**PROPOSED BANQUET HALL
KEMPER LAKE
KEMPER COUNTY, MISSISSIPPI**

**PAT HARRISON WATERWAY DISTRICT
HATTIESBURG, MISSISSIPPI**

ADDENDUM NO. 2

Revisions to Proposal and Contract Documents and Plans for the referenced project are as follows:

E1.1

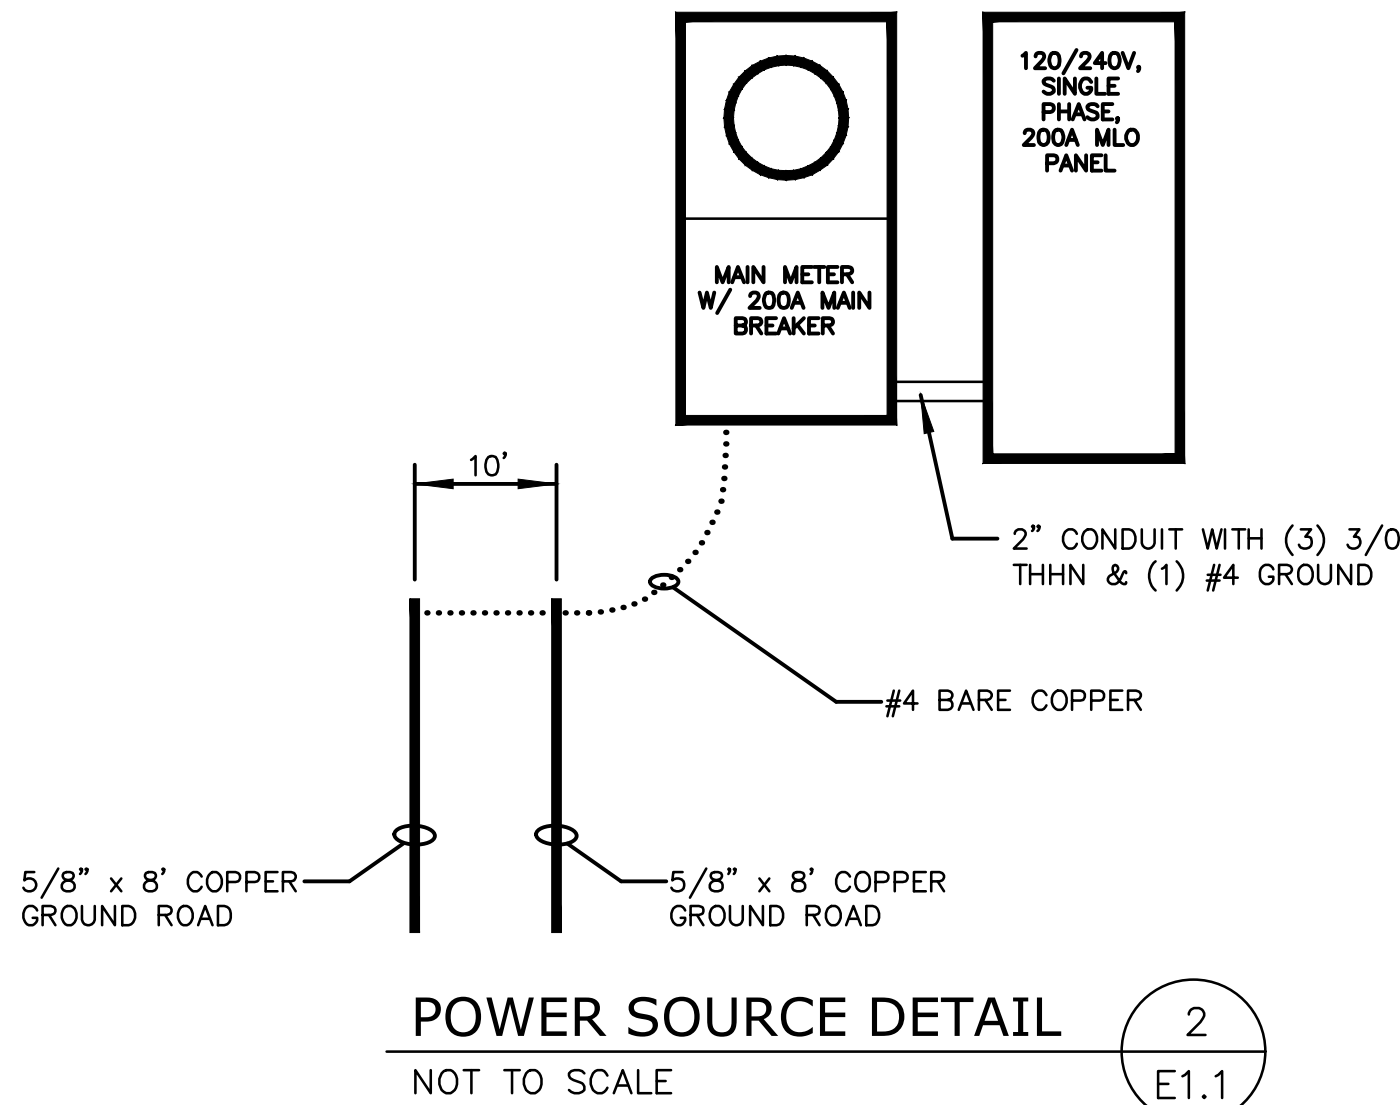
1. **REPLACE:** Sheet E1.1 with the attached revised sheet E1.1.
2. **CLARIFICATION:** Handicap restroom stalls shall be furnished with 1@36" and 1@42" stainless steel grab bars installed to comply with Department of Justice ADA standards.
3. **CLARIFICATION:** Restroom partitions shall be solid plastic restroom partitions.
4. **CLARIFICATION:** Each restroom shall be furnished with a 48" x 36" mirror above the sinks; wall mounted, single roll toilet tissue holders with shelf, BWE A-91021-N or equivalent, and a PT-1 Bobrick Model B-262 paper towel dispenser or equivalent.
5. **CLARIFICATION:** Owner will furnish the refrigerator and stove.
6. **CLARIFICATION:** No Federal Funds are involved in this project. There are NO wage rate requirements.
7. **NOTE:** All materials and installation to meet current ADA standards.

NO.	REVISION	DATE
1	PANEL SCHEDULE AND DETAILS	7-14-25
